STATE OF DELAWARE
EXECUTIVE DEPARTMENT
OFFICE OF MANAGEMENT AND BUDGET
STATE PLANNING COORDINATION

RE: PLUS review – 2008-01-11; Cypress Hall Commercial

Thank you for meeting with State agency planners on January 23, 2008 to discuss the proposed plans for the Cypress Hall Commercial project to be located on the southwest corner of Route 113 and Shawnee Road.

According to the information received, you are seeking site plan approval through the City of Milford for a 218,200 sq. ft. shopping center.

Map of Cypress Hall (PLUS 2008-01-11). The site plan is overlain on the site. The dark red area shows the wellhead protection area.

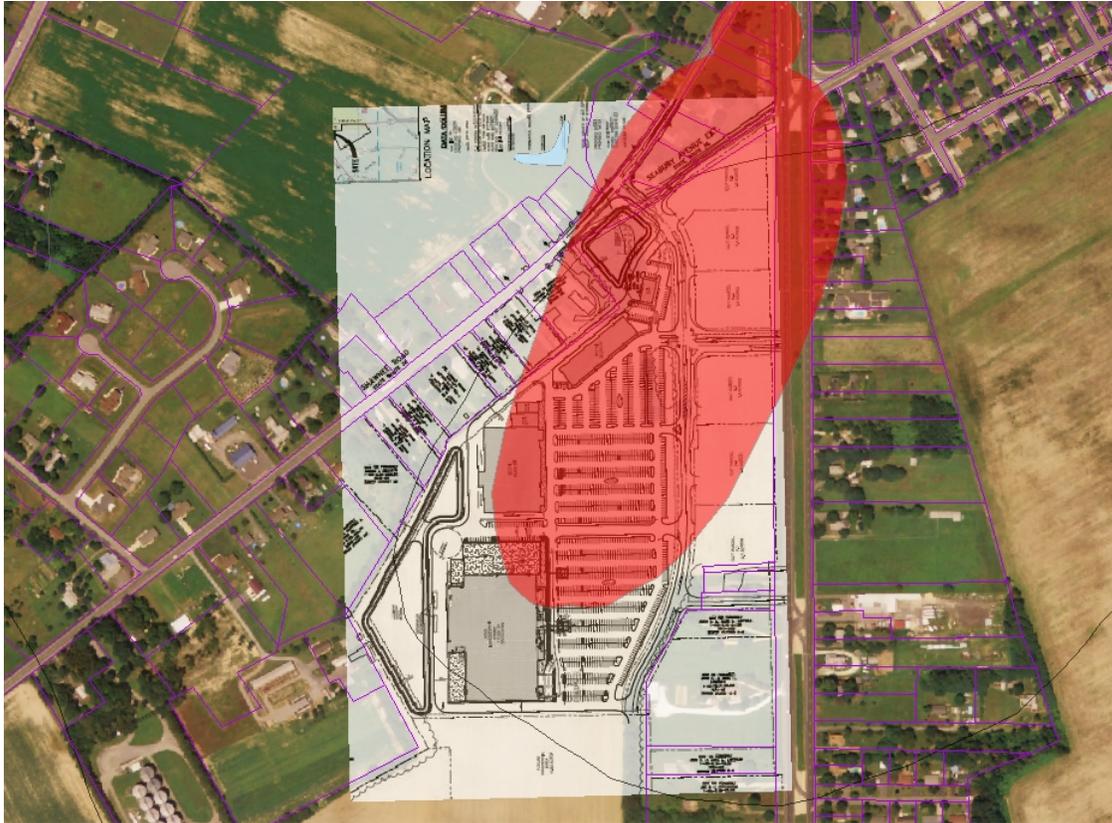
The Water Supply Section, Ground Water Protection Branch (GWPB), has determined that a significant portion falls within a wellhead protection area for Milford Water (see following map and attached map). Wellhead protection areas are surface and subsurface areas surrounding a public water supply well where land use activities or impervious cover may adversely affect the quantity and quality of ground water moving toward these wells.

The Water Supply Section recommends that the portion of the new development within the wellhead protection area not exceed 20% impervious cover. Some allowance for augmenting ground-water recharge need be considered if the impervious cover exceeds 20% but is less than 50% of that portion of the parcel within this area. However, the development should not exceed 50% regardless. An Environmental Impact Assessment

The proposed development would change the impervious cover from 0% to approximately 72%. The Developer provided these numbers on the PLUS application form. Ideally, relocating any open space areas to the part of the parcel within the wellhead protection area would decrease the total impervious area in the wellhead protection area. Augmenting the ground-water recharge with clean rooftop run-off systems are another alternative to reducing the total impervious cover.

- Reduce impervious cover to a value less than 50% dependent on an environmental assessment. The environmental assessment must document that post-development recharge will be no less than predevelopment recharge when computed on an annual basis.
- Maintain the portion of the wellhead protection area within the development as open space with low maintenance vegetation that does not require herbicides, pesticides, or fertilizers.
- Divert stormwater runoff away from the wellhead.
- Incorporate pre-engineered inlet filters designed to remove urban pollutants such as hydrocarbons into the storm drain system as pre-treatment prior to discharge to infiltration facilities or other stormwater management BMPs designed primarily for TSS reduction.
